*TB 1-1520-248-20-42

DEPARTMENT OF THE ARMY TECHNICAL BULLETIN

INSTRUCTIONS FOR REPLACING OH-58D T703-AD-700B ENGINE WITH T703-AD-700A

Headquarters, Department of the Army, Washington, D. C.
20 July 2000

Figure 1. Locally Manufactured Discharge Duct Assembly

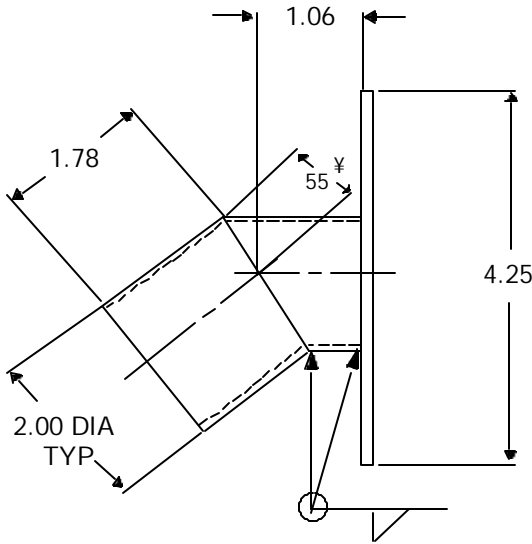
(3) Locally fabricate a cowl duct. Fabricated duct should have a 2.0 inch outside diameter (OD) inlet tube, and approximately a 4.25 inch OD flange. See Figure 1.

(4) Match drill eight equally spaced 3/32 inch diameter holes through locally fabricated cowl duct, removed flange/screen, and cowl.

(5) Install fabricated cowl duct and flange/screen on inside of cowl using eight MS20470B3 rivets and eight 104-001-11 washers.

- S All dimensions are in inches.
- S Flange Plate is 0.080 inch aluminum stock.
- S Tubing is aluminum with 0.063 inch wall thickness.
